DEVELOPMENT APPLICATION

APPLICATION NUMBER:	PLN-25-171
PROPOSED DEVELOPMENT:	Three lots subdivision (two new lots plus balance)
LOCATION:	22 Wrights Avenue Glenorchy
APPLICANT:	Rogerson & Birch Surveyors
ADVERTISING START DATE:	17/07/2026
ADVERTISING EXPIRY DATE:	31/07/2026

Updated Concept Services Plan

Stormwater Management Proposal

Client	McKAY INVESTMENT PTY LTD
Drawing Title	STORMWATER GENERAL ARRANGEMENT

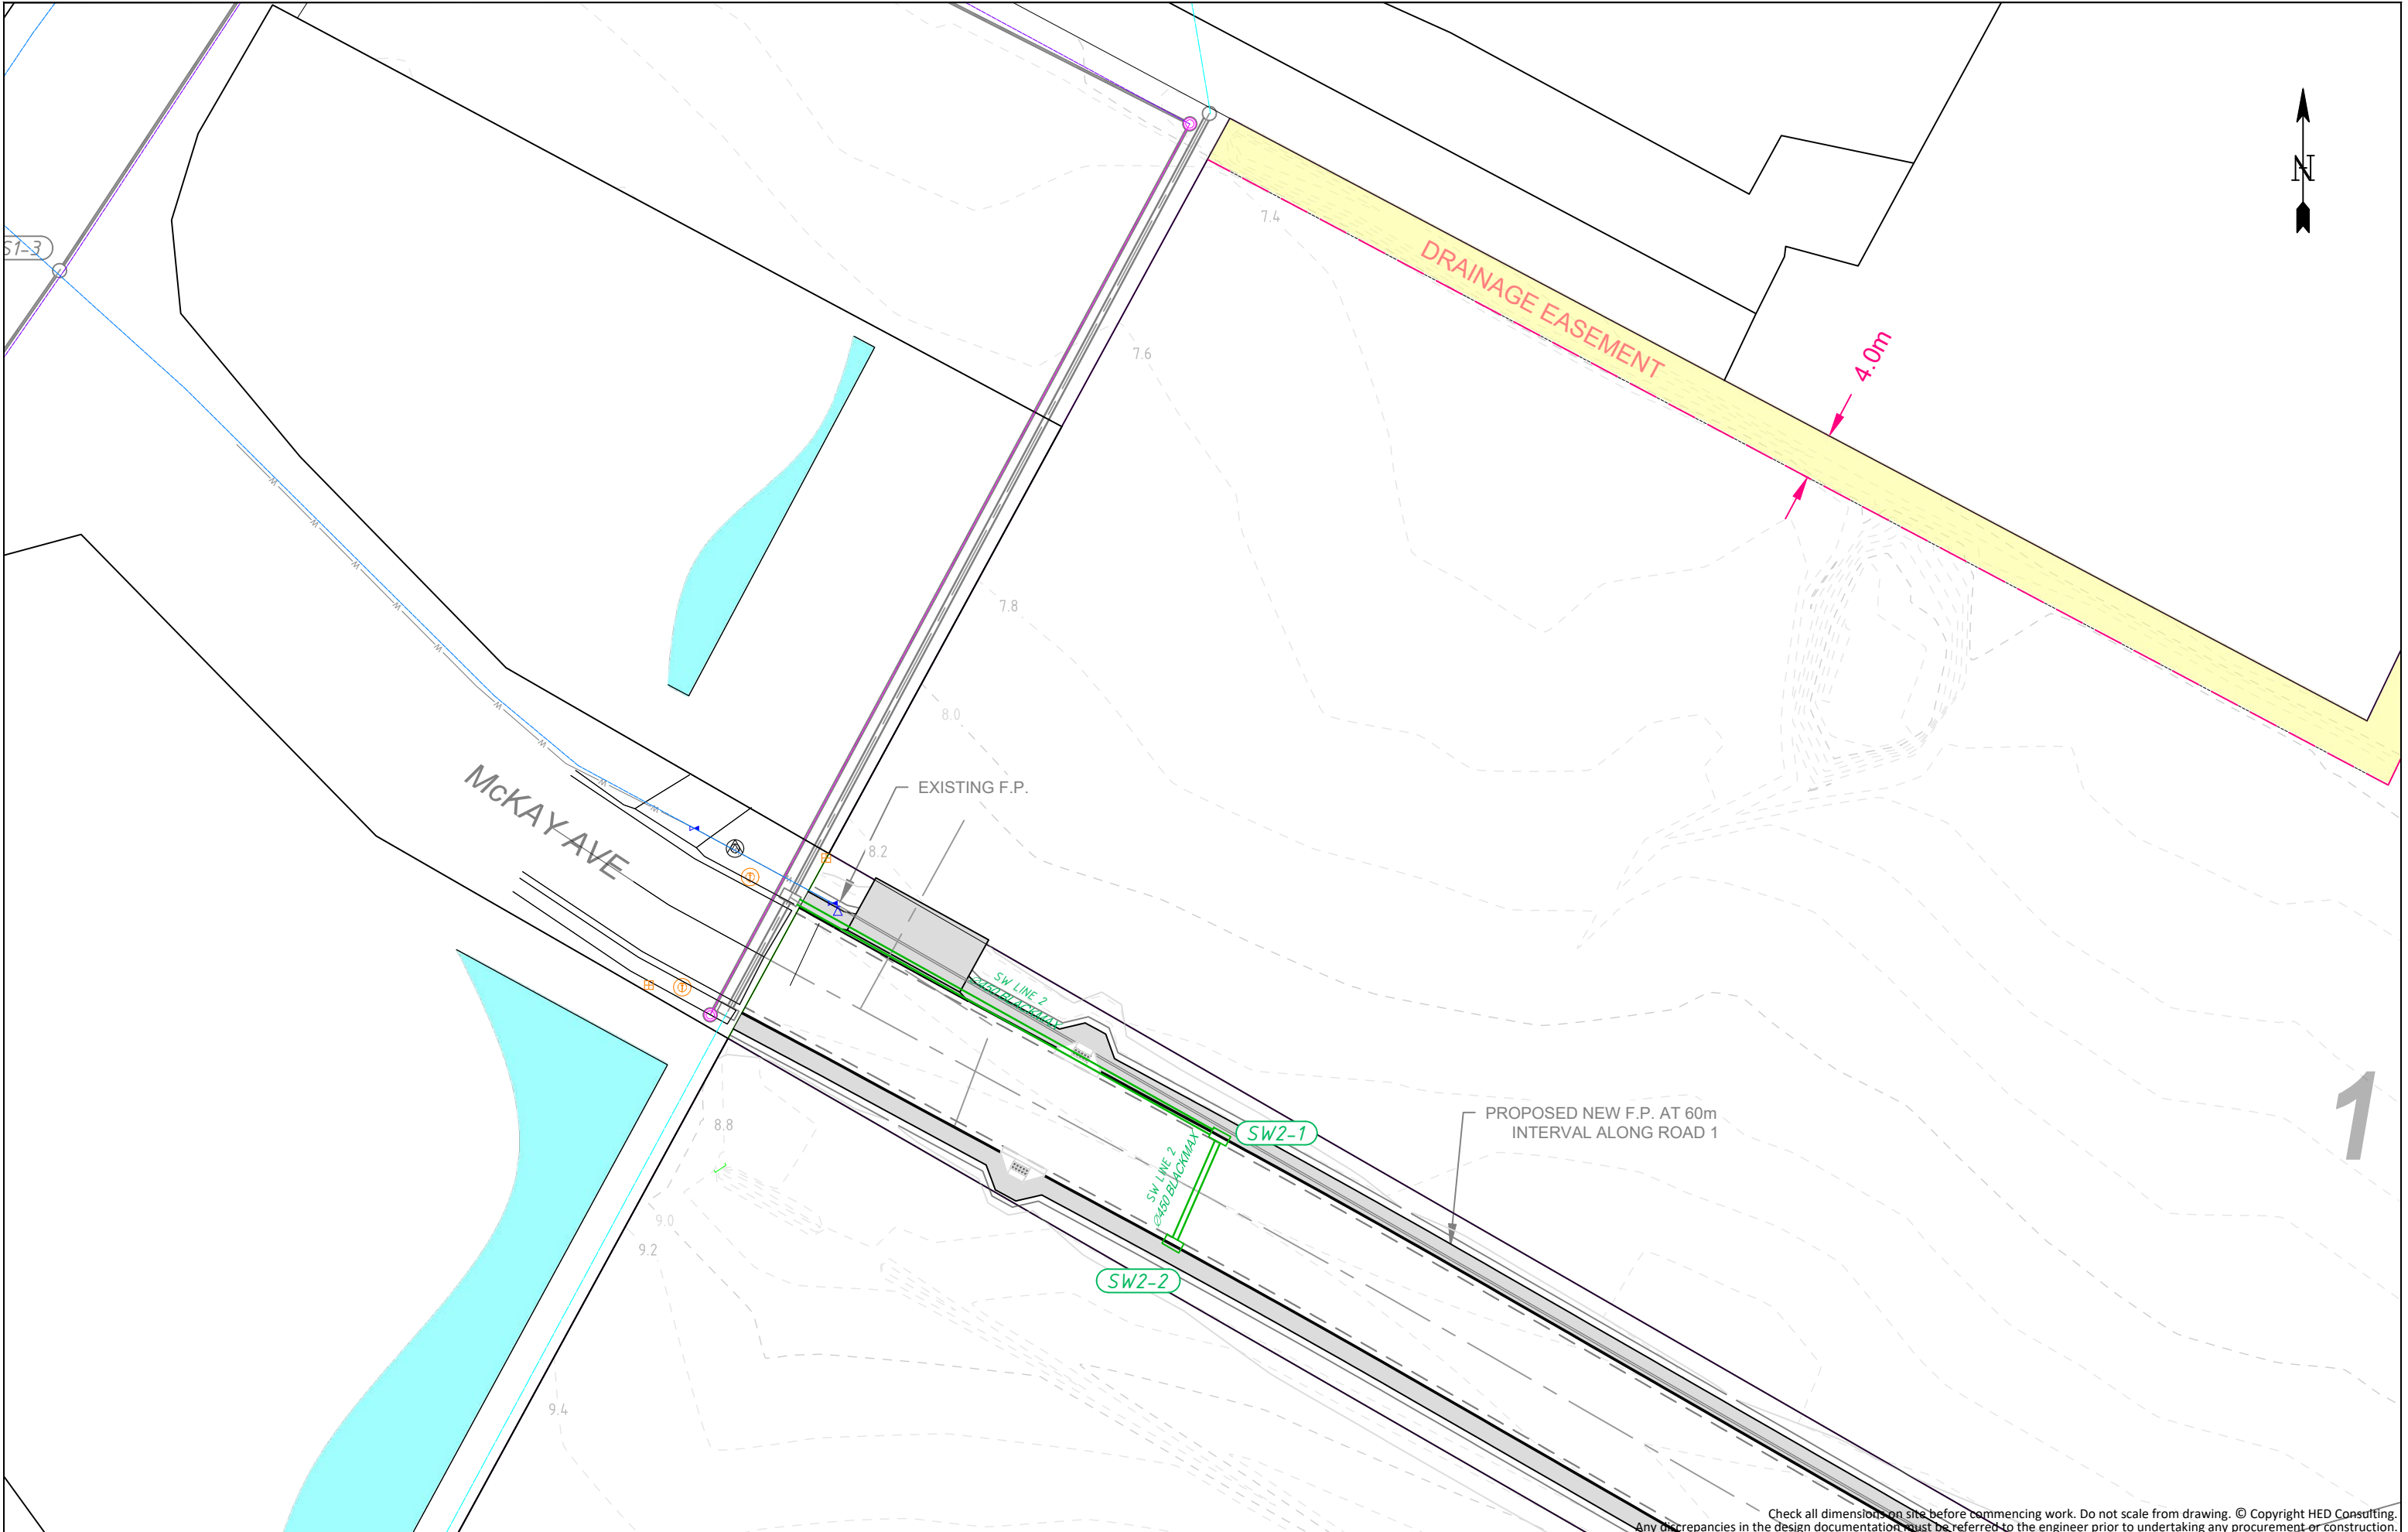
It has been brought to attention in council's RFI, dated 04/03/2026, that the proposed new SW infrastructure shown in subdivision concept plan H-1-001 and H-1-003 (revision 1) cross under the existing electrical substation on the eastern side of the northern McKay Avenue. However, it was found that it is not feasible to have SW infrastructure run along the western side of the northern McKay Ave to avoid clashing with existing substation. Further investigations have found that the existing high and low voltage electrical mains were fed from the subdivision across the McKay Ave, then runs along the western side of the road. Furthermore, it was found telecommunications mains were on both side of the McKay Ave and gas main is running along the western side of the road as well within the edge of travel way.

The existing DN300 SW infrastructure on the northern McKay Ave, runs through the existing property, 1 McKay Ave, then discharge into Humphreys Rivulet. The existing DN300 SW pipes have approximately 600mm cover within the road reserve. We believe neither pipe cover nor the hydraulic capacity of the existing DN300 lines are sufficient for the proposed subdivision drainage.

With the findings illustrated above, it is proposed (in the amended subdivision drawings - Revision 3) to have the proposed lot 1, lot 2, and northeast catchment of the balance lot and subdivision road drained directly into the Humphreys Rivulet. The revised SW infrastructure will not interfere with any existing services.

It is proposed to have a minimum 6m wide easement along the northern boundary of lot 2 to incorporate an underground SW detention tank and treatment system prior to discharge runoff into existing watercourse. The discharge outlet shall have riprap and reduced flow for scour protection. The proposed SW treatment shall meet council's Water Quality Treatment Target. A preliminary hydraulic model has indicated all development within each lot of the subdivision will require onsite SW detention prior to discharge into SW mains. The discharging flow rate shall be governed by the receiving capacity of the SW treatment system provided by the product manufacturer. The proposed measures are considered to meet the performance criteria outlined in the C7.6.1 in Tasmanian Planning Scheme.
